City Hall/Town Hall

December 7, 2015

Del Mar City Council

Project Status

Parking Access – Alt. 5B

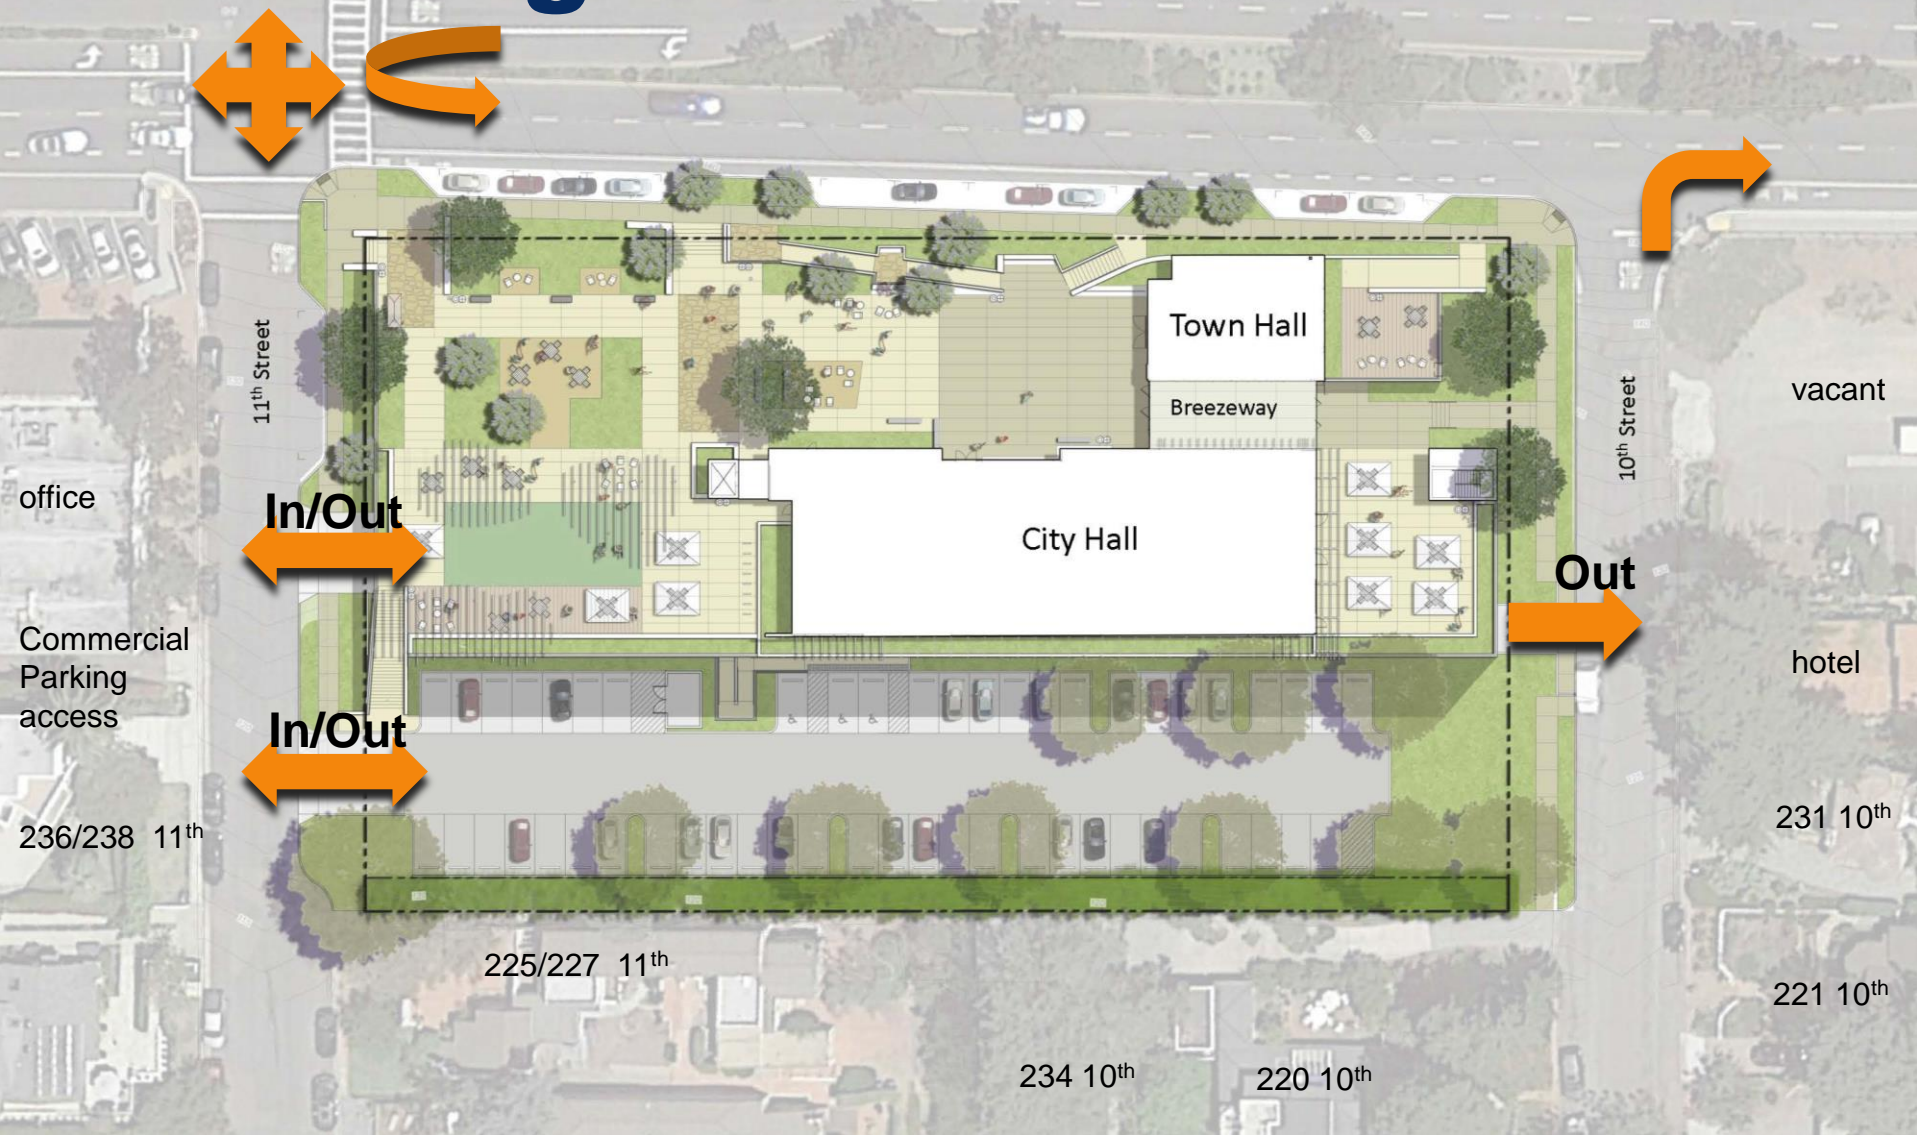
10th Street: Break CDM median to allow 4-way stop at 10th Street; concern of impacts to CDM traffic flow

Parking Access – Alt. 7

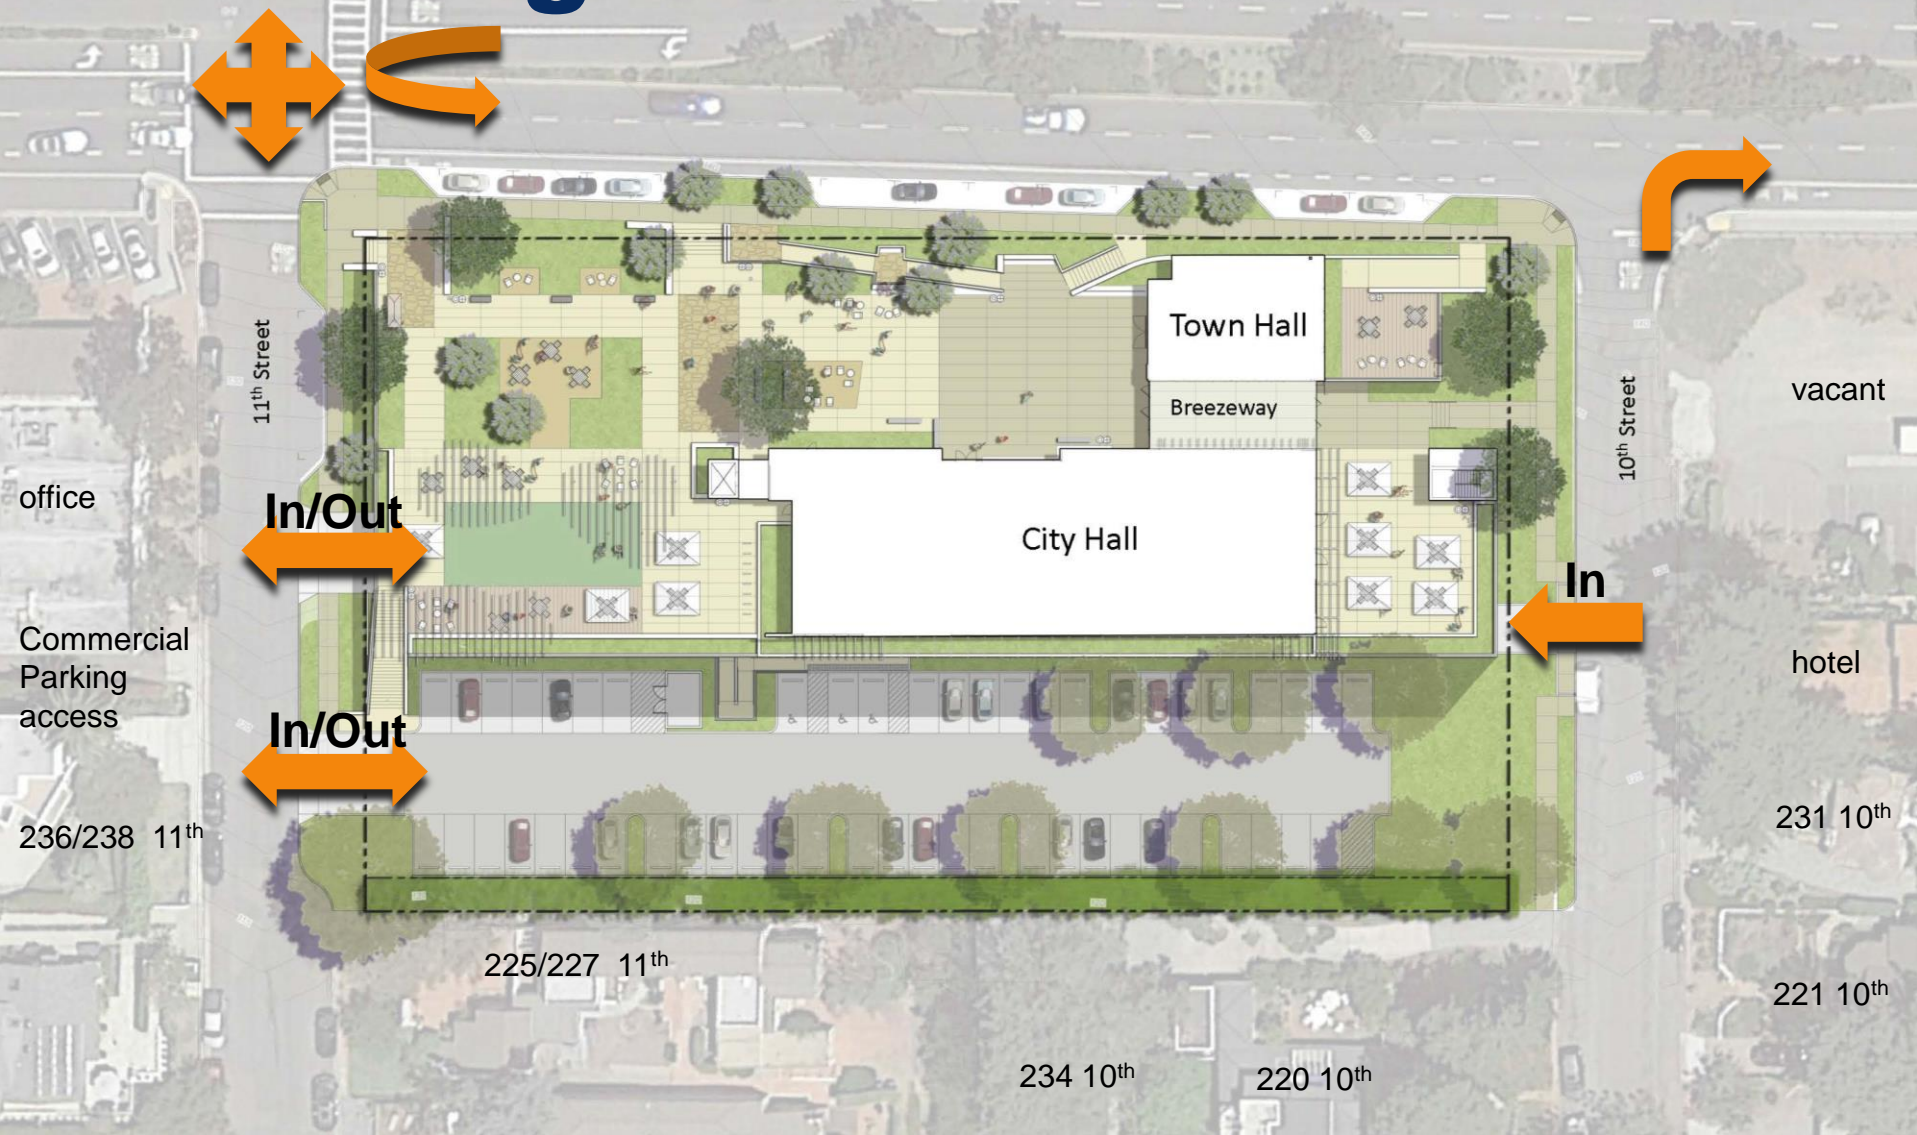
Reduce number of parking stalls to lessen traffic.
